CITY OF FREDERICKSBURG HISTORIC REVIEW BOARD

TUESDAY, MARCH 15, 2022

7. CERTIFICATE OF APPROPRIATENESS APPLICATIONS

CURRENT WEST VIEW

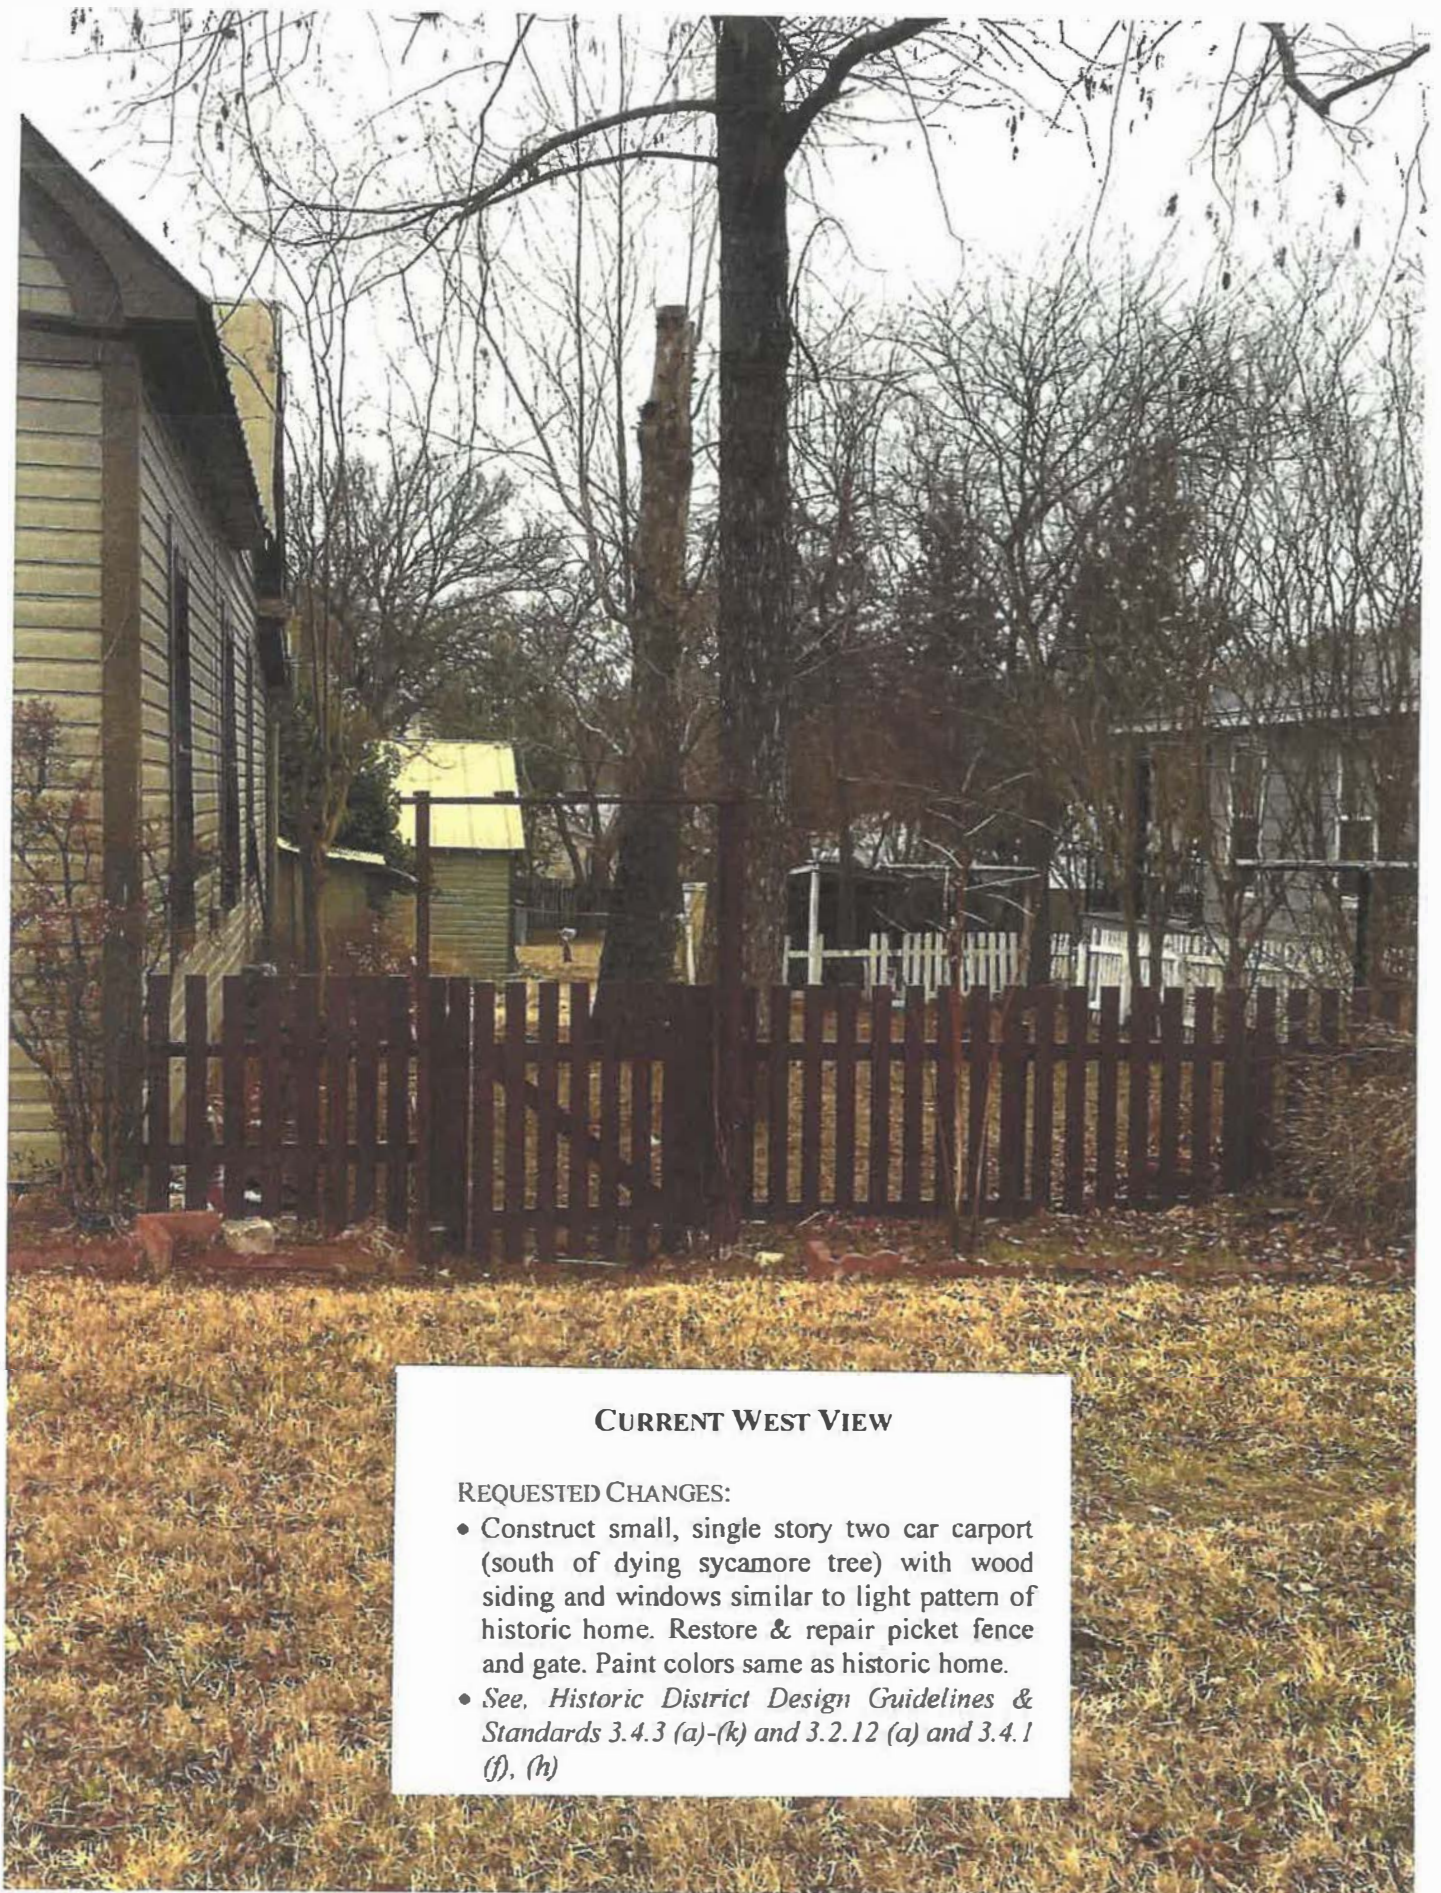
- Replace roof with galvalume turned-top (seam ridge) standing seam
- See, *Historic District Design Guidelines & Standards 3.2.3 (i), (m)*
- Install fire code compliant window in gable. Window will be custom made wood window with similar pattern.
- See, *Historic District Design Guidelines & Standards, pgs 1-16, 1-17*
- Note: all other gable ends have a window.

CURRENT SOUTH VIEW

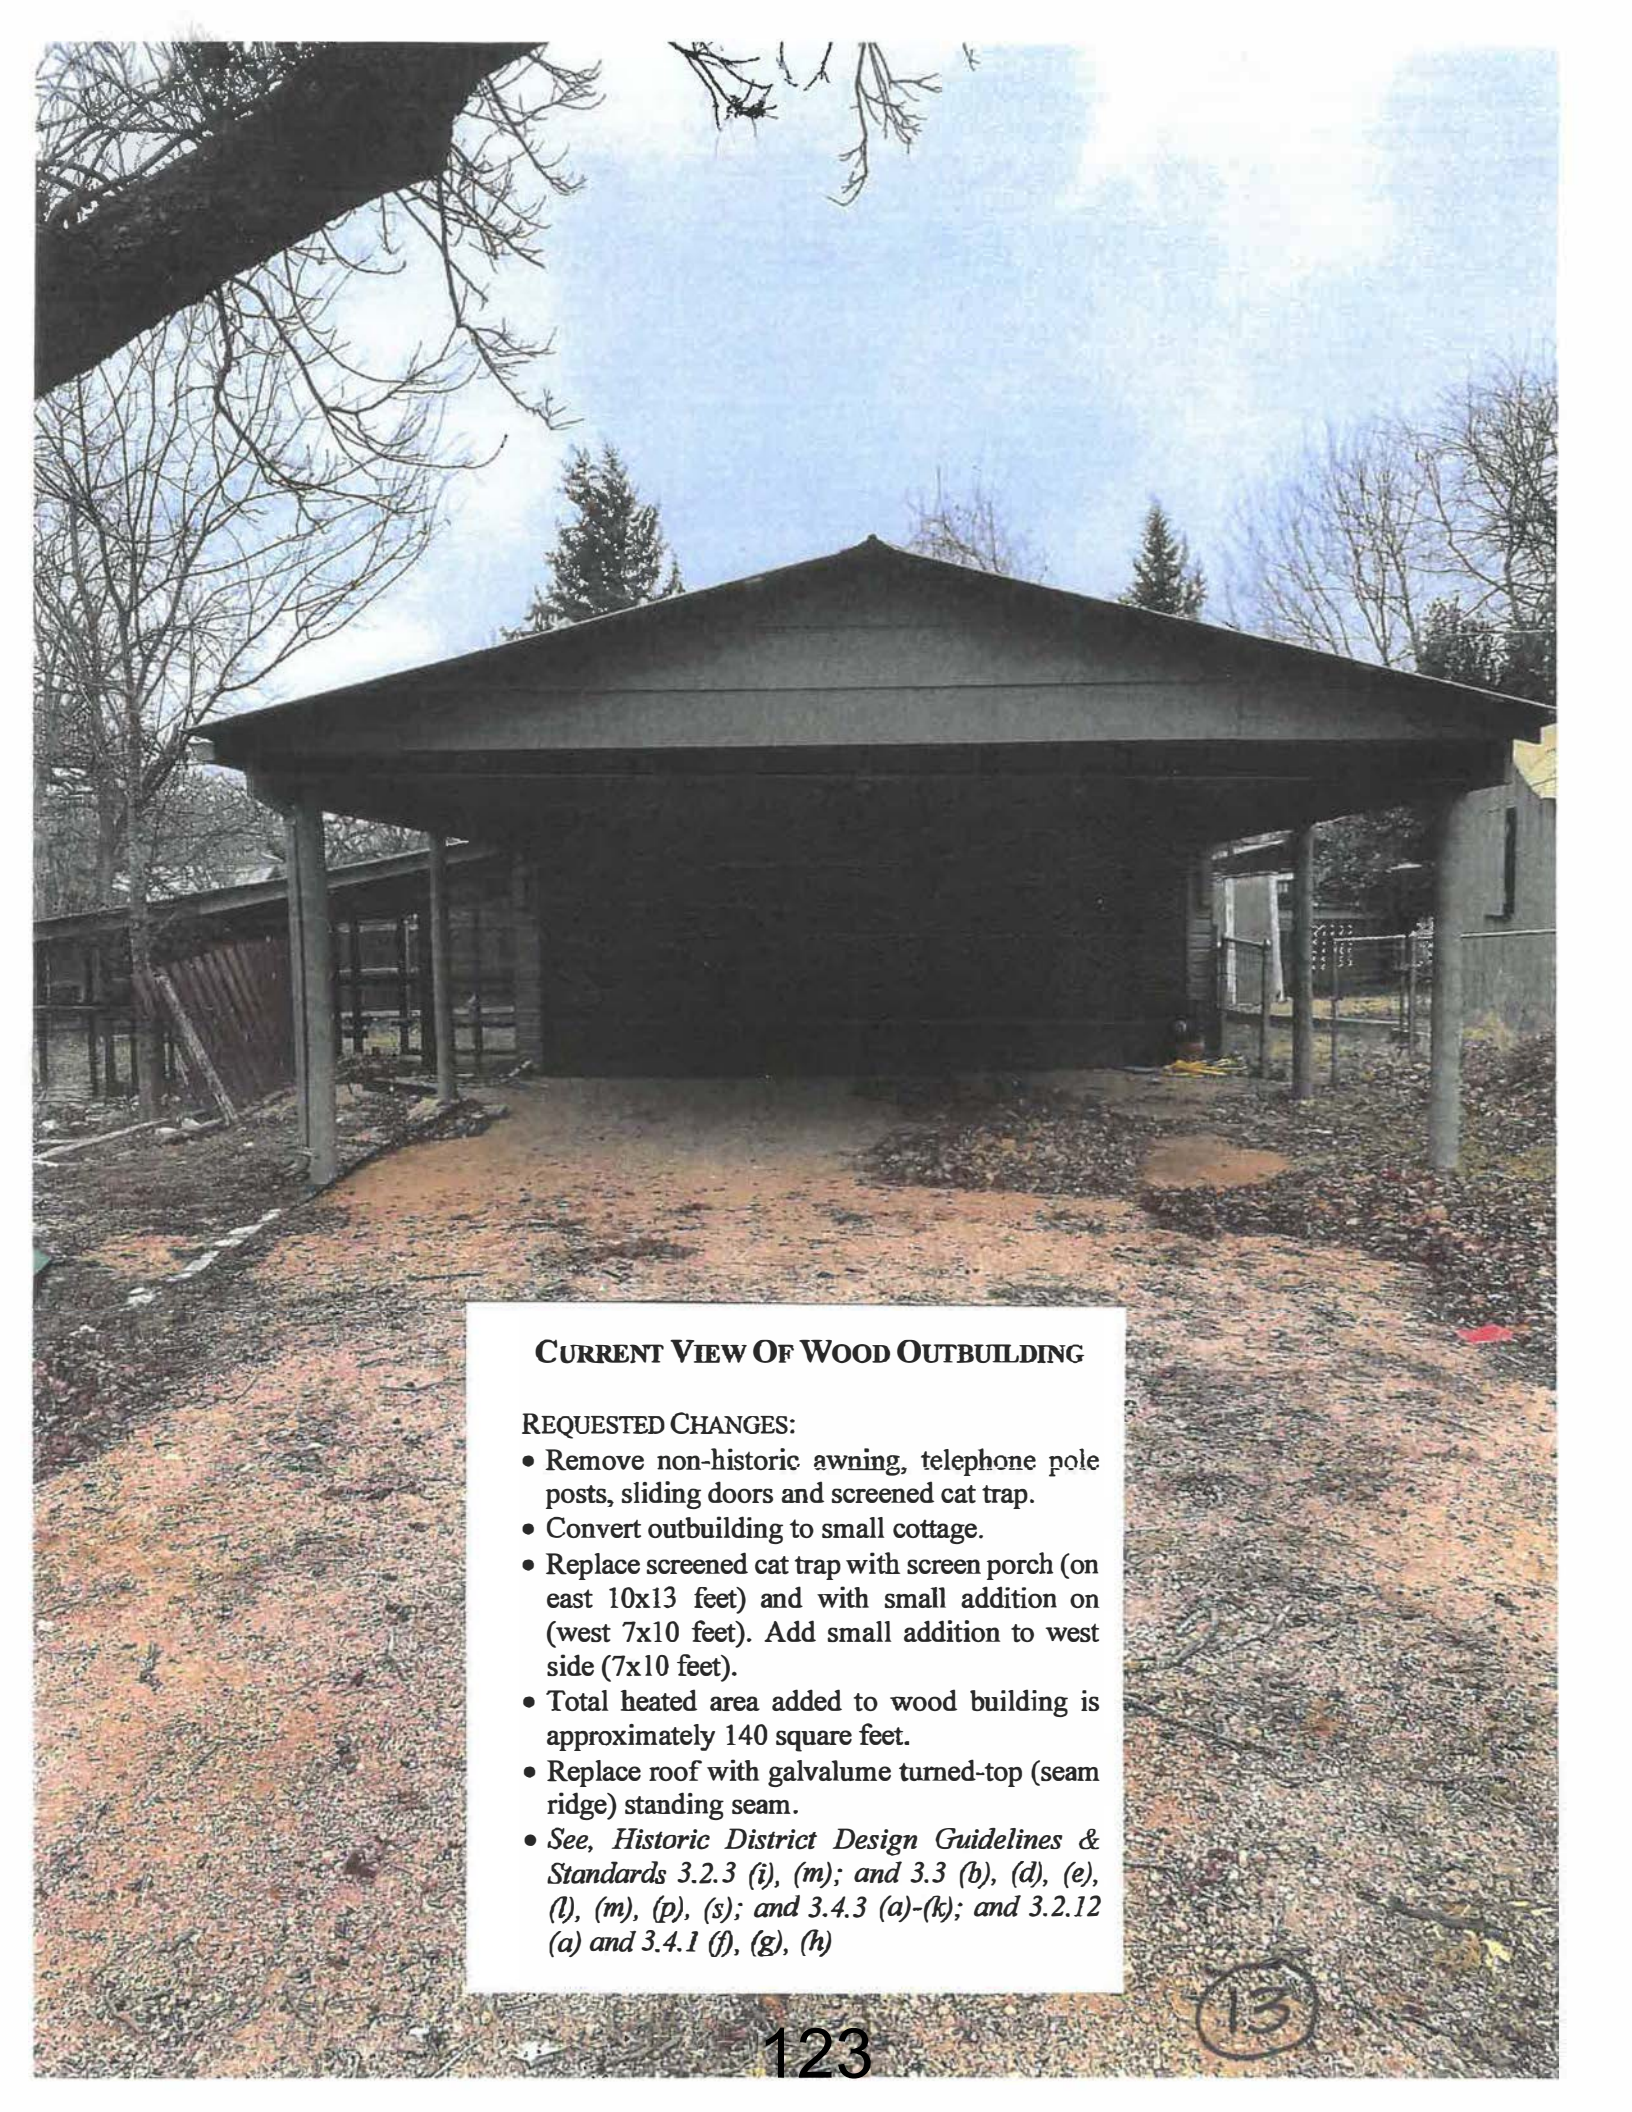
- Replace roof with galvalume turned-top (seam ridge) standing seam
- Remove the non-historic addition which was constructed improperly under the historic design standards (no inset corner, failure to use differentiating material, failure to align floor plate) and dangerous stairs.
- Replace with guideline/standard complying addition that adds approximately 190 square feet to existing structure.
- See, *Historic District Design Guidelines & Standards* 3.3 (b), (d), (e), (l), (m), (p), (s) and 3.4.1 (f), (g), (h) and 3.2.3 (i), (m)

CURRENT VIEW OF WOOD OUTBUILDING

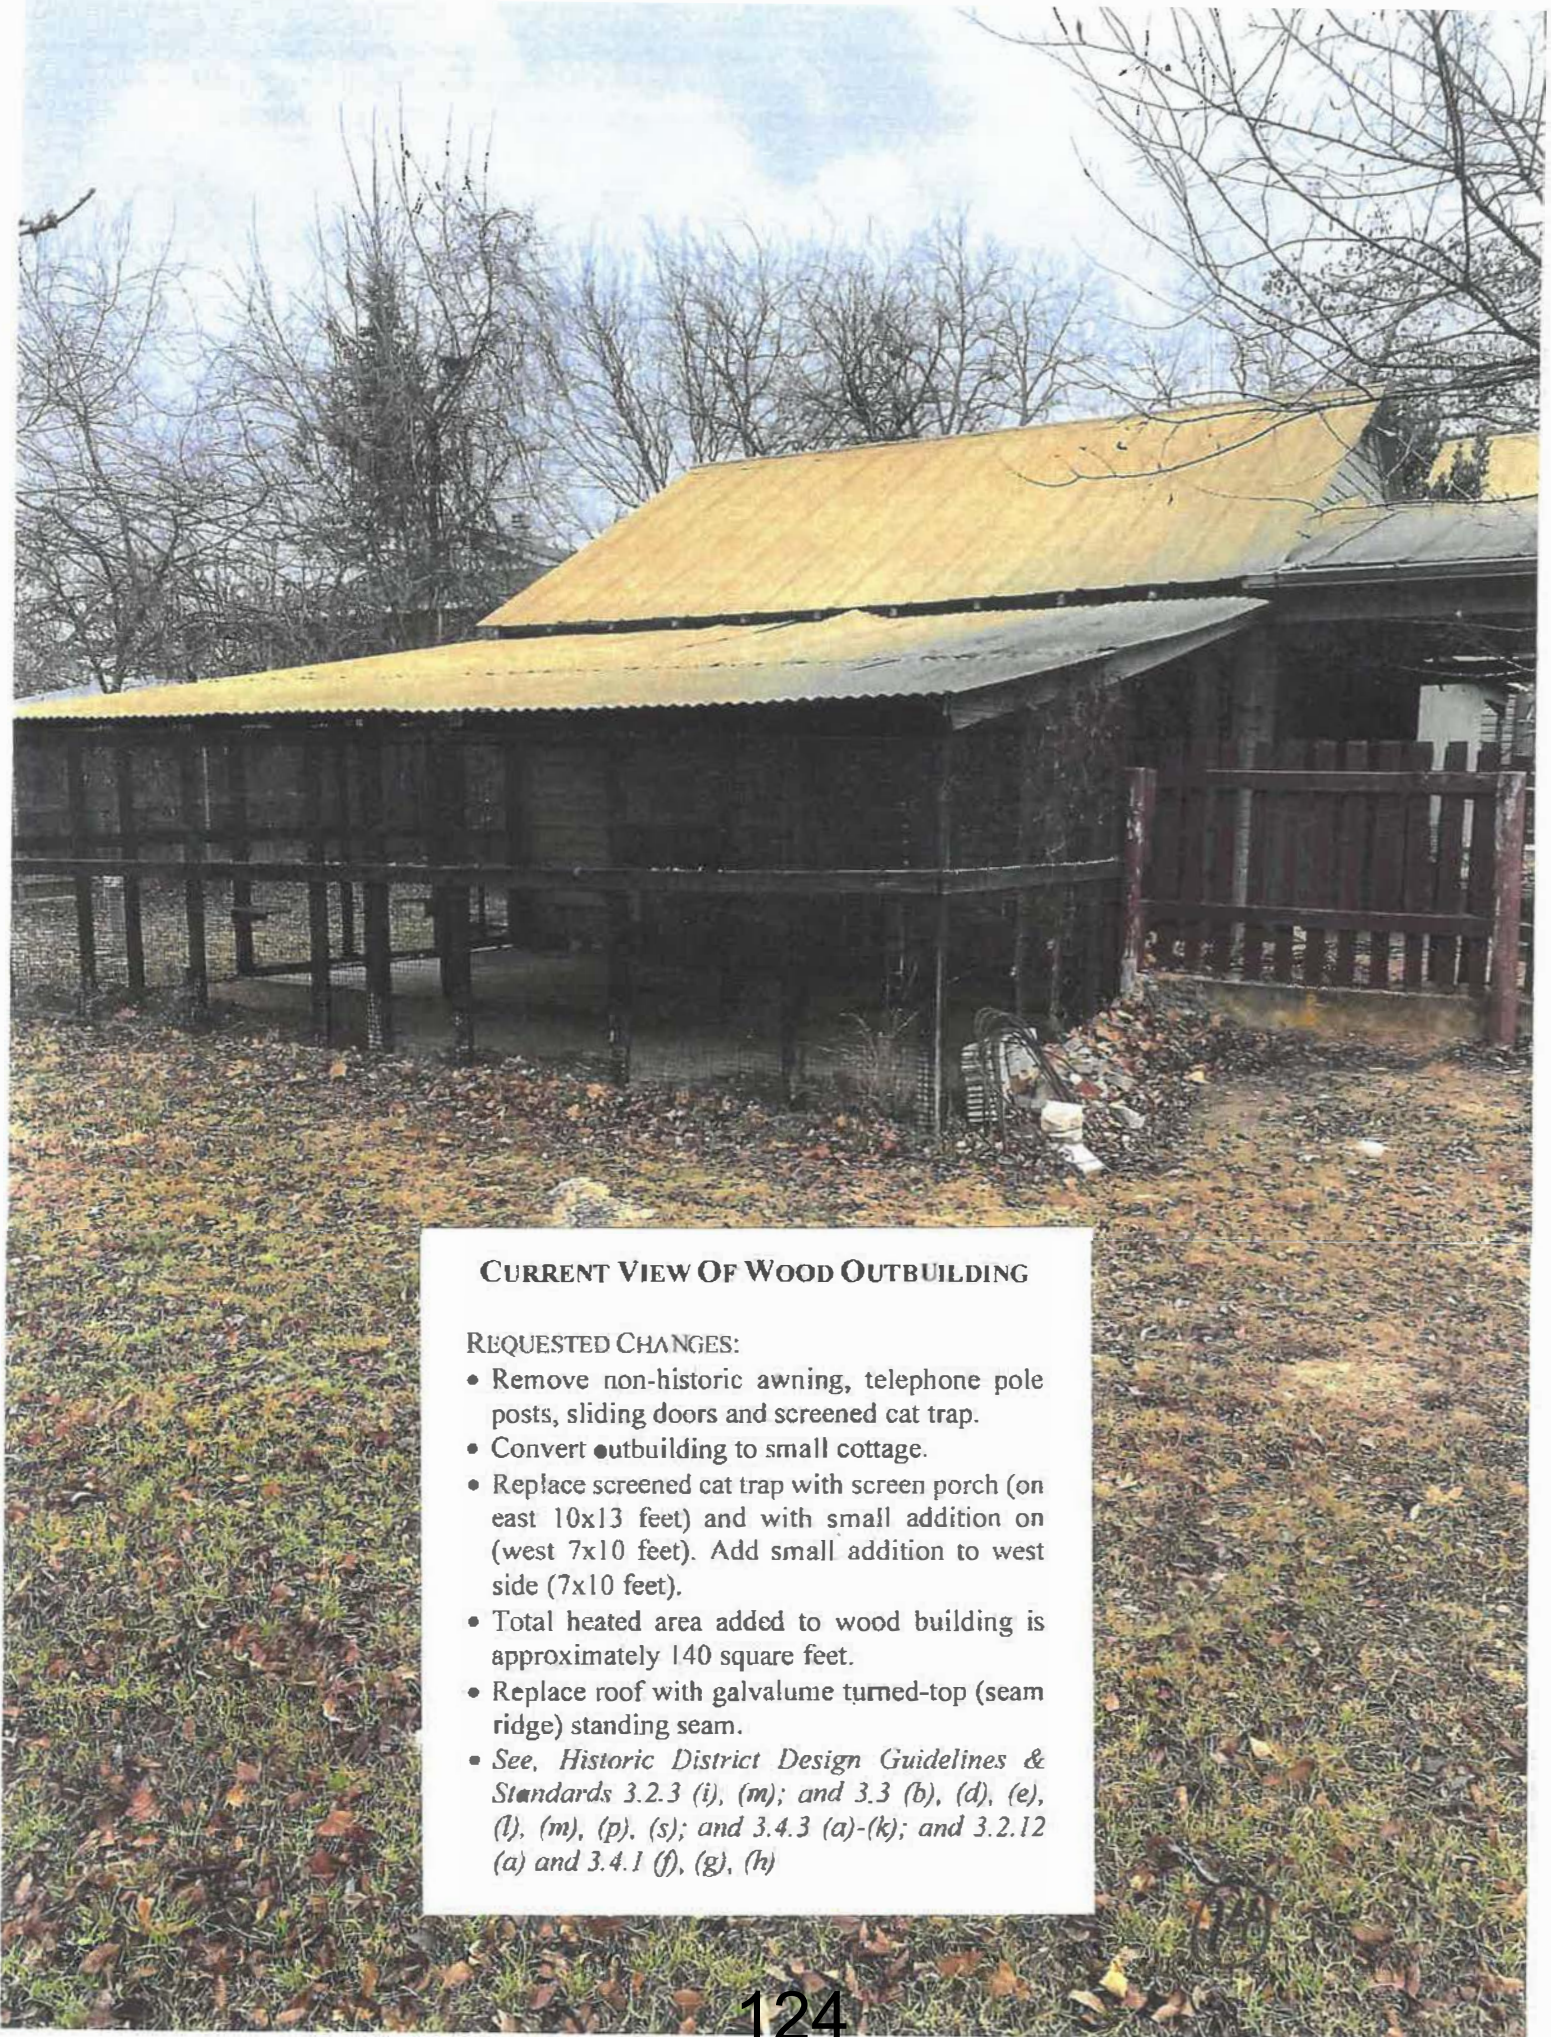
- Remove non-historic awning, telephone pole posts, sliding doors and screened cat trap.
- Convert outbuilding to small cottage.
- Replace screened cat trap with screen porch (on east 10x13 feet) and with small addition on (west 7x10 feet). Add small addition to west side (7x10 feet).
- Total heated area added to wood building is approximately 140 square feet.
- Replace roof with galvalume turned-top (seam ridge) standing seam.
- See, *Historic District Design Guidelines & Standards* 3.2.3 (i), (m); and 3.3 (b), (d), (e), (l), (m), (p), (s); and 3.4.3 (a)-(k); and 3.2.12 (a) and 3.4.1 (f), (g), (h)
